IDAP REPORT

Property:	8 Marion Street STRATHFIELD Lot: 81 DP: 12405 DA2020/254
Proposal:	Additions and alterations to an existing dwelling house within a heritage conservation area (Marion Street Conservation Area - C12) comprising of a rear extension, first-floor addition and restoration works, construction of alfresco area and in-ground swimming pool.
Applicant:	DM Investments Aust Pty Ltd
Owner:	Joseph Abdal and Layla Yarak
Date of lodgement:	18 January 2021
Notification period:	3 February – 17 February 2021
Submissions received:	None
Assessment officer:	E Black
Estimated cost of works:	\$285,000.00
Zoning:	R2-Low Density Residential - SLEP 2012
Heritage:	Yes – Located within the C12 Marion Street Conservation Area, Inter-war bungalow style group
Flood affected:	Yes
Is a Clause 4.6 Variation Proposed:	No
RECOMMENDATION OF OFFICER:	APPROVAL

Image 3: Landscape Plan showing new fence design and driveway

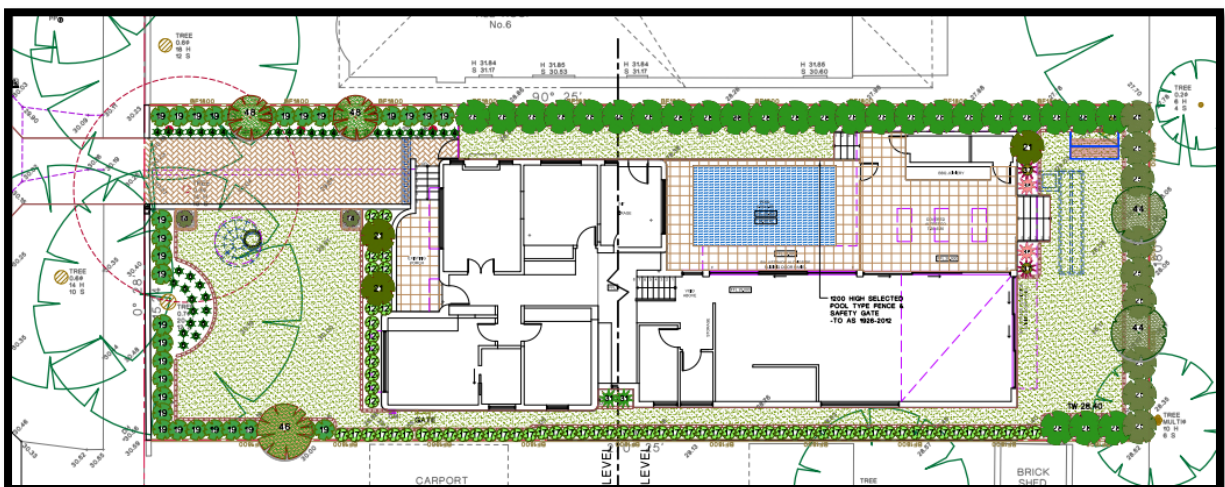
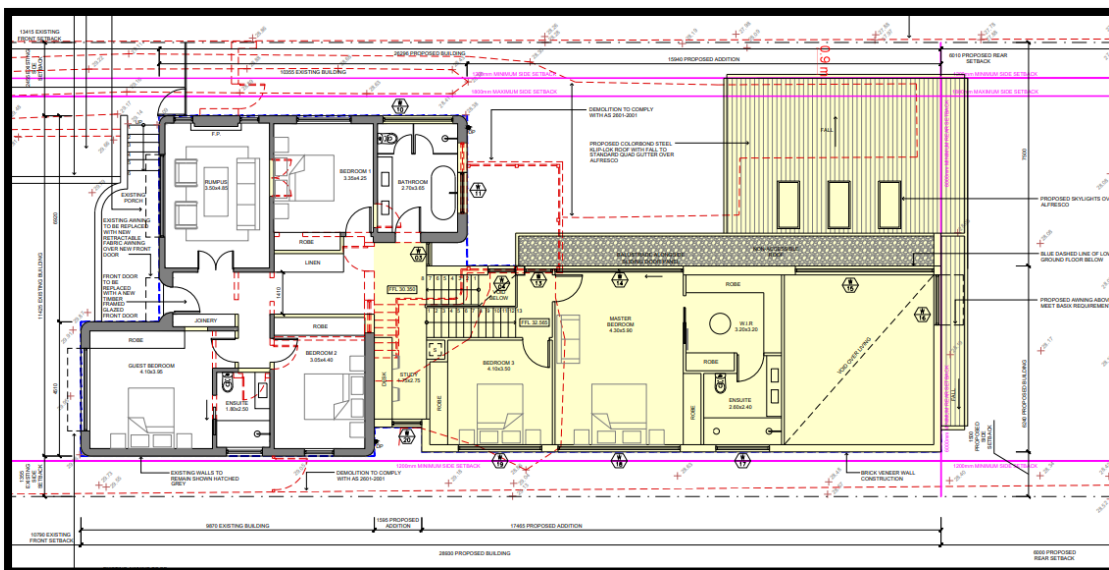
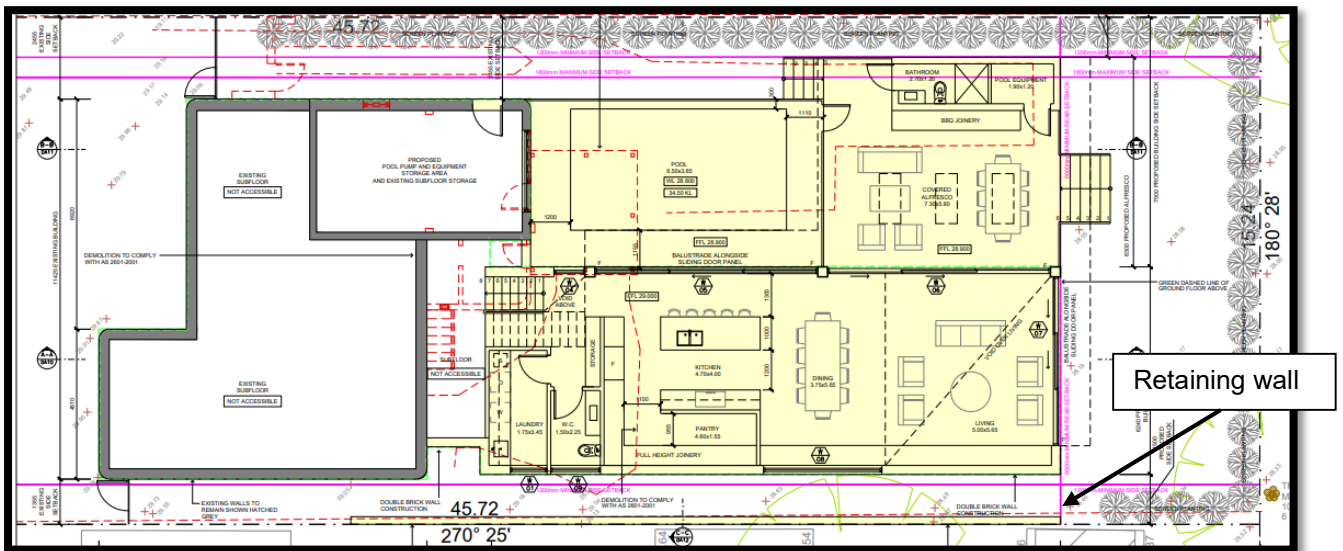
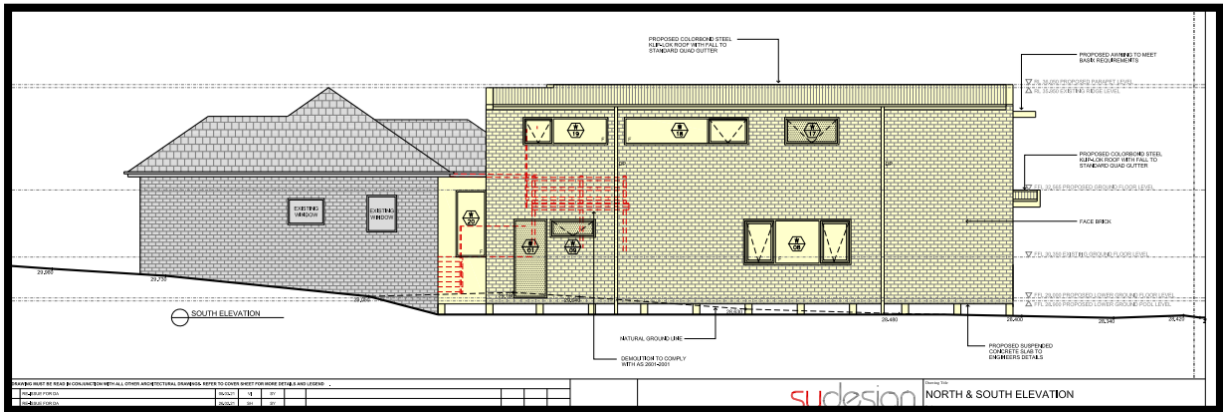
I do not support the removal of the base of the Chimney below the eave, the design of the driveway and the removal of the small retaining wall as they will impact on the setting of the HCA. The removal of these elements will not meet Part P - Heritage Section 4.9 Landscape elements including paving and driveway as such conditions and plan changes in relation to this section have been included. These are below:

The Tree Co-ordinator could not support the location of the current placement of the watertank and the stormwater pipes in the front setback. The potential of the pipes poses a threat to three significant trees. These being the brush box street tree where the pipes are proposed to be within the root system of the tree, the neighbouring eucalyptus tree and the significant eucalyptus tree in the front yard. This results in the storm water management plan being unacceptable and requires the water tank to be moved from the front yard area and the water pipes to be relocated away from the three trees (including the street tree). The tree co-ordinator has requested a change to the plans prior to Construction Certificate to maintain the current crossing.

- a. *The bricks from the period retaining wall in the front setback to be reused in any new retaining walls.*
- b. *The front driveway be redesigned to allow for a section of the driveway to be of a track design. Track driveways are a feature of the Marion Street Conservation Area. That the landscape plan is altered to reflect this and approved by the Heritage Advisor Prior to Construction Certificate.*
- c. *The front door is replaced with either a period 1930's door or a replica of a 1930's door to be approved by Council's heritage consultant prior to Construction Certificate.*

a) The stormwater outlet pipe to the street is to be relocated to the immediate north of the existing driveway away and the water-tank relocated to under part of the driveway away from neighbouring trees. The new stormwater plan must be approved by Councils Tree Management Officer and Development Engineer prior to the issue of the Construction Certificate.

b) The half circle front boundary fence is to be made of light-weight materials, elevated above the soil surface and textured the match or contrast the main masonry boundary fence. This light weight is to be supported at 3 contact points into the ground to protect the root system of the Eucalyptus Scoparia. The fence must be approved by Councils Heritage Advisor prior to the issue of the Construction Certificate.
